## **INSPECTION PHOTOS NO.**

## ROOF MASTERS

Job Address:
47622 Wisteria Lane

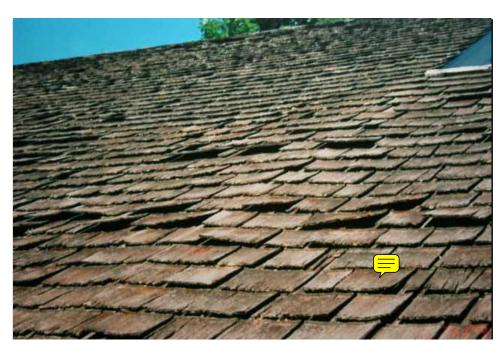
The main leak you are experiencing is a result of loose, missing and broken shingles in this area shown to the left. At this point in the life of your roof, 26 years old, we recommend a complete re-roof. You will not have to worry about this problem happening again for the life of the new roof. If you choose Lamarite composite slate shingles, the expected roof life will be 50 years!
